AIP CANADA (ICAO) SUPPLEMENT 3/18

ADJUSTMENT OF THE RESTRICTED AIRSPACE CYR538 RIDEAU HALL, OTTAWA, ONTARIO

(Replaces AIC 24/17)

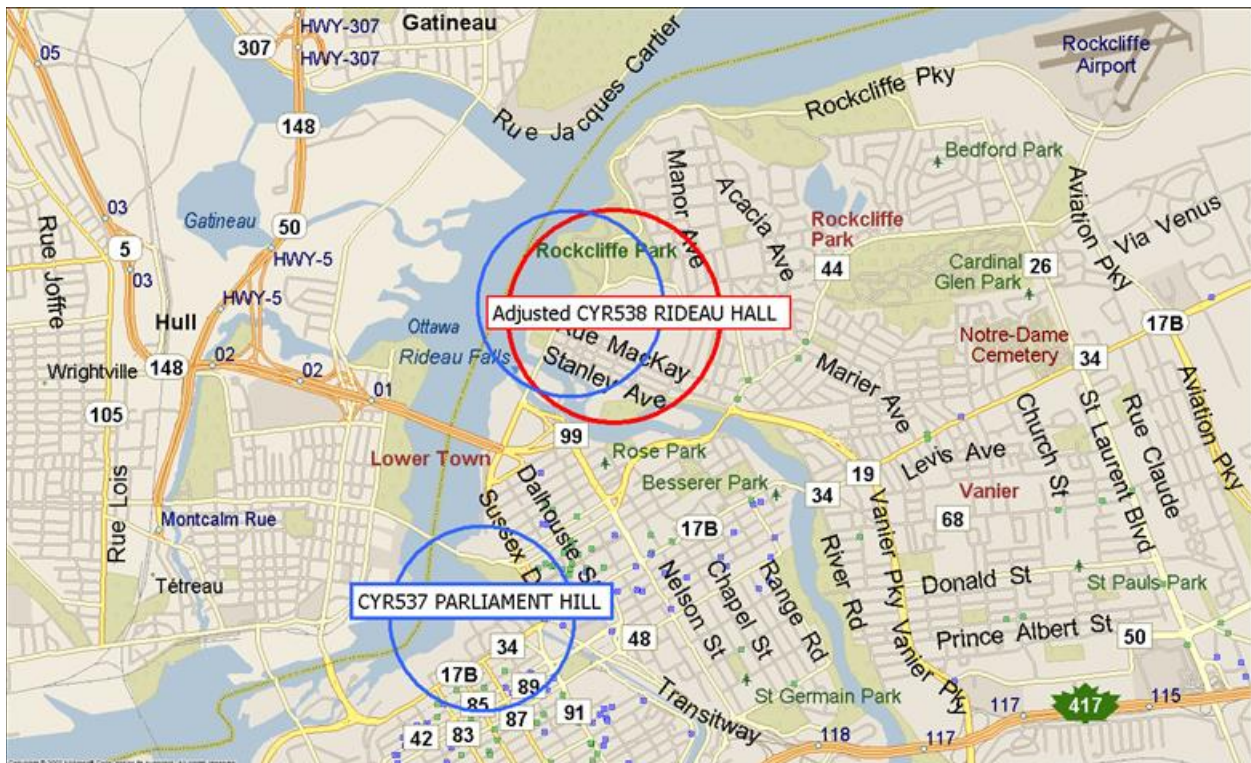
At the request of the Royal Canadian Mounted Police (RCMP), NAV CANADA, the country's provider of civil air navigation services, has adjusted the location and dimension of the restricted airspace CYR538 over the Governor General's Residence, Rideau Hall. The purpose of this change is to enhance the security of the Rideau Hall buildings and grounds.

The new dimension and coordinates of this restricted air space are defined as the airspace within the area bounded by a circle of 0.4 nautical mile radius centered on 45° 26' 38.90" N 075° 41' 17.80" W, from the surface to 3,000 feet above sea level (ASL). (See map sketch below.)

This change takes effect 07 December 2017, at 09:01 Coordinated Universal Time (UTC). Refer to this AIP Supplement until the amended Ottawa visual flight rules (VFR) terminal area chart (VTA) (AIR 1905) is available in May 2018.
